Access Compliance Report

Public Rights-of-Way

Intersection ID: 32316	Main Street: NEW_PROVIDENCE_LN	Cross Street: WOODCLIFF_CT	Location: N
ADA ID: CC6E6358F4E3	Ramp Type: Perp	Initial Pass/Fail: Fail	Overall Compliance: No
Severity Score: 33.75			
Codes/Mitigation Info/Possible Solution		Field Measurements/Component Compliance

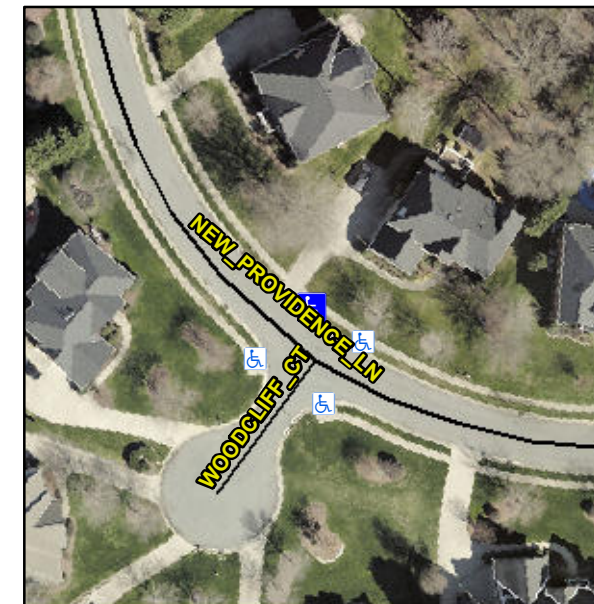
Not Found, R304.5.1, R304.2.2, R304.5.3

Compliance	Description	Data	Compliance	Description	Data
N/A	Ramp Length (in)	47.5	No	Ramp Slope (%)	9.7
No	Ramp Width (in)	45.0	No	Ramp XSlope (%)	5.8
N/A	Flare Type LT	N/A	N/A	Flare Type RT	N/A
N/A	Flare Slope LT (%)	N/A	N/A	Flare Slope RT (%)	N/A
N/A	Flare Traversable LT?	N/A	N/A	Flare Traversable RT?	N/A
N/A	Landing Length (in)	N/A	N/A	DWS Provided?	N/A
N/A	Landing Width (in)	N/A	N/A	DWS Contrast?	N/A
N/A	Landing Slope (%)	N/A	N/A	DWS Length (in)	N/A
N/A	Landing X Slope (%)	N/A	N/A	DWS Full Width?	N/A
N/A	Landing Curb? (Y/N)	N/A	N/A	DWS Offset (in)	N/A
N/A	Shared Landing?	N/A			
N/A	Gutter Ponding?	N/A	N/A	Gutter Slope (%)	N/A
N/A	Gutter Lip Ht (in)	N/A	N/A	Gutter X Slope (%)	N/A
N/A	Painted X Walk1?	No	N/A	Painted X Walk2?	N/A
	X Walk 1 Direction	To SW		X Walk 2 Direction	N/A
N/A	X Walk 1 Width (in)	N/A	N/A	X Walk 2 Width (in)	N/A
	X Walk 1 Slope (%)	3.1		X Walk 2 Slope (%)	N/A
	X Walk 1 X Slope (%)	3.4		X Walk 2 X Slope (%)	N/A

Remove & Replace Entire Ramp.
